SUBJECT: Requests NRC approval of QA program changes in order to  
implement performance-based nuclear assessment program.  
Proposed changes incorporating changes in nuclear assessment  
program & results of discussions w/NRC encl.

H. B. ROBINSON STEAM ELECTRIC PLANT, UNIT NO. 2  
DOCKET NO. 50-261/LICENSE NO. DPR-23  
REQUEST FOR APPROVAL OF  
QUALITY ASSURANCE PROGRAM CHANGES

CHANGE DESCRIPTIONS REQUIRING NRC APPROVAL ,  
INCLUDING REASONS/BASIS FOR CHANGE

# RNP Proposed Nuclear Assessment Section

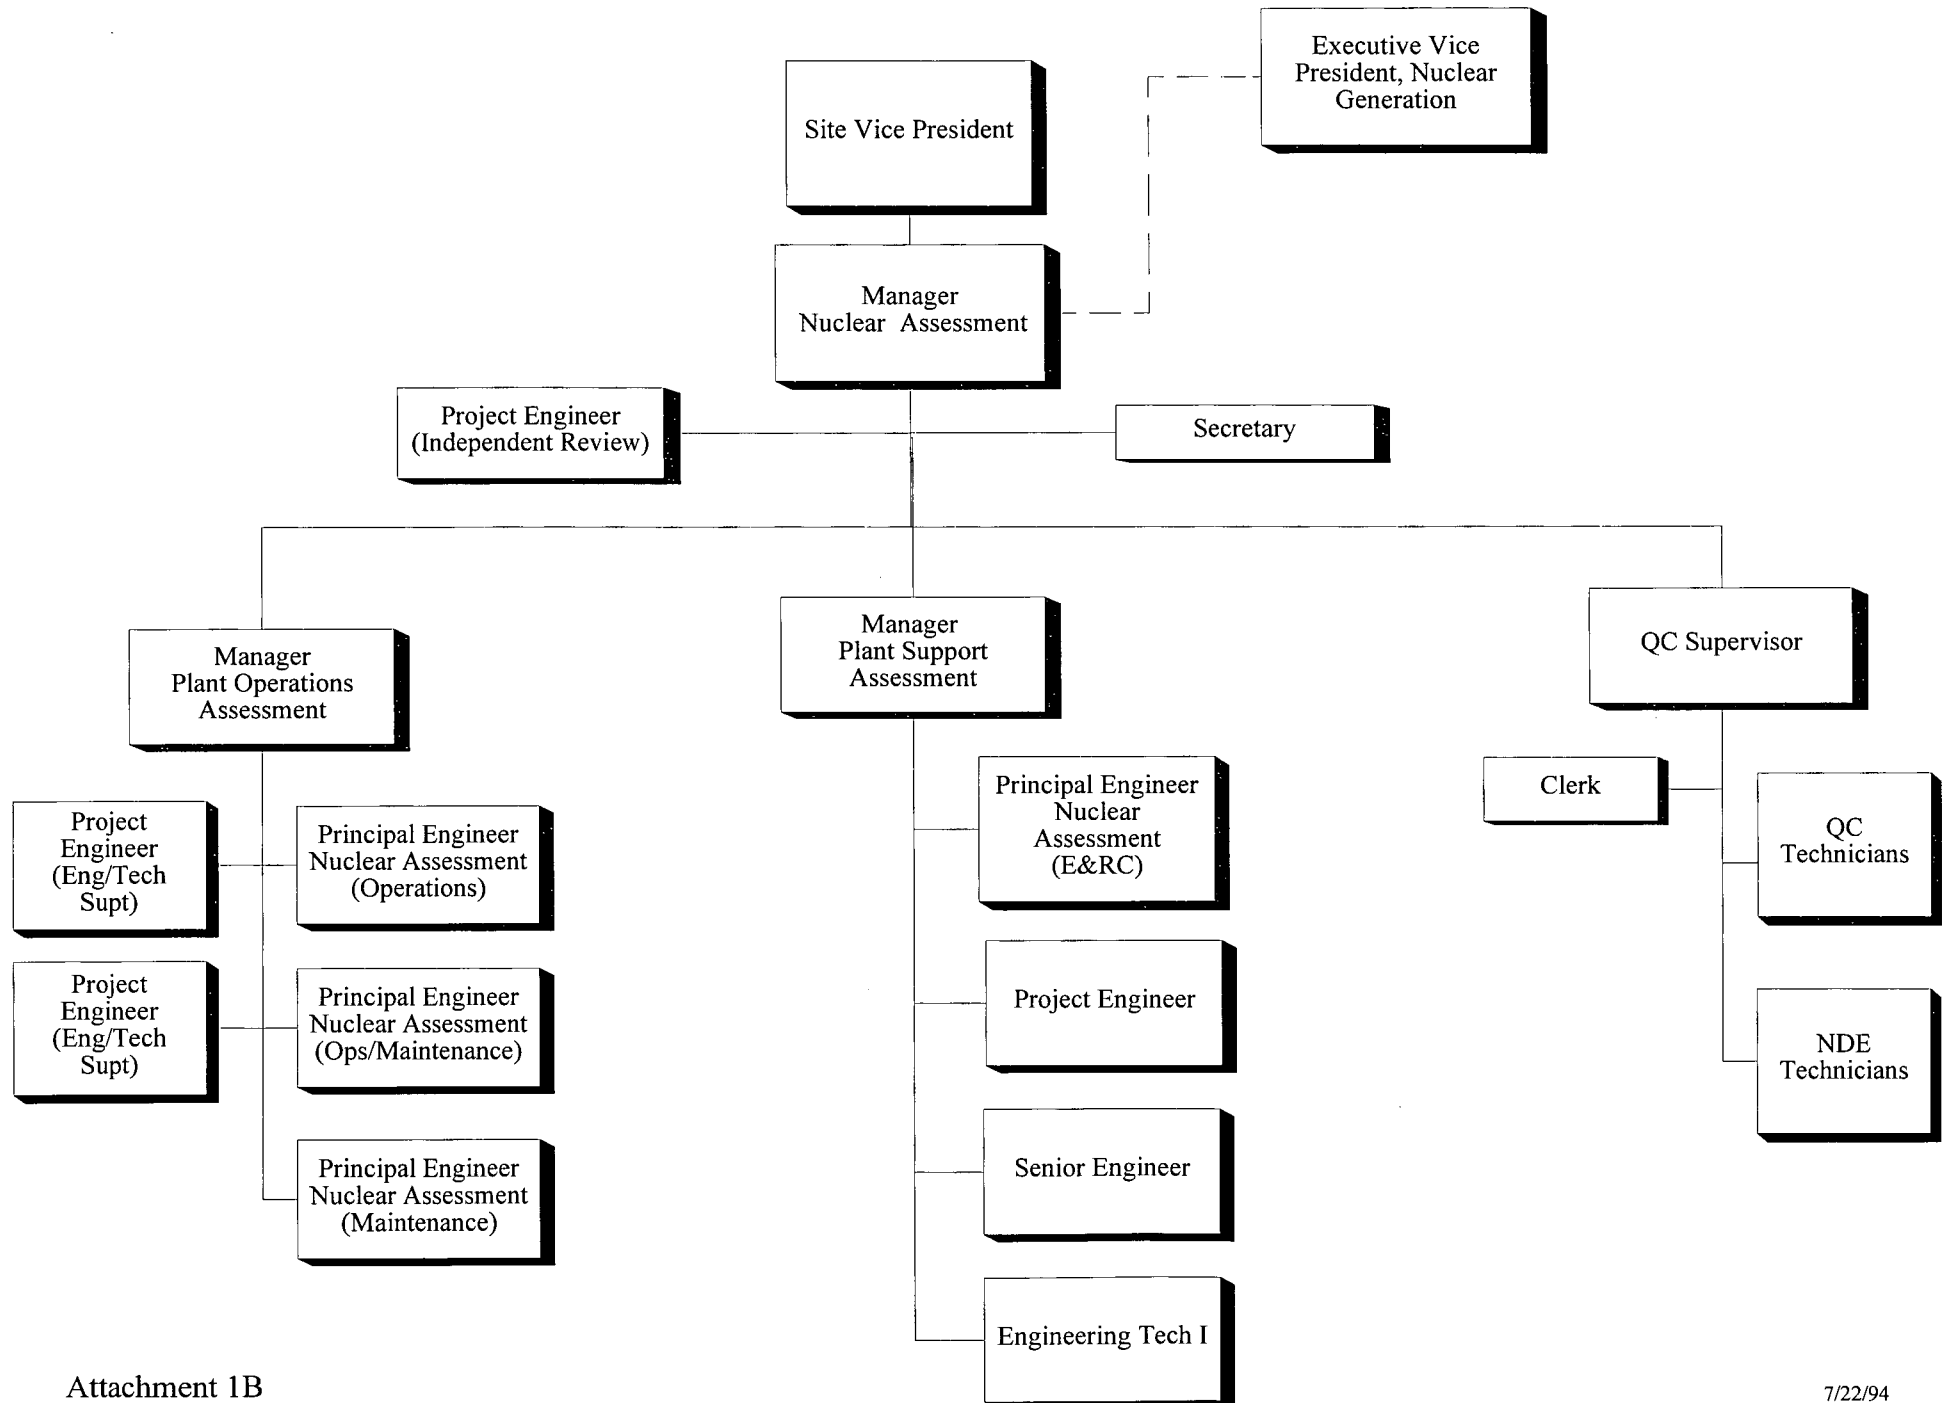
The proposed reorganization eliminates the NAD and realigns the plant NAS, reporting to the Site Vice President. The assignment of NAS as a direct report provides a valuable resource to the person held fully accountable for plant performance. The NAS will continue to conduct performance-based assessments to meet the 10 CFR 50, Appendix B, regulatory-required audits, and will assess to the Institute for Nuclear Power Operations (INPO) performance standards rather than minimum compliance standards.

The NAS Manager will report to the most senior CP&L manager on site, the Site Vice-President. This will ensure independence from the plant production organization. Other nuclear utilities have developed similar organizational arrangements for their quality assurance organizations.

The NAS has been aligned consistent with the current NRC Systematic Assessment of Licensee Performance (SALP) categories. The NAS organization is provided for your information in Attachment 1B. The responsibilities for the Plant Operations and Plant Support Units are discussed below:

- Plant Operations - responsible for Operations, Maintenance, and Engineering and Technical Support.
- Plant Support - responsible for Environmental and Radiation Control and other support areas such as Emergency Preparedness, Security, Document Control, and Material Control.
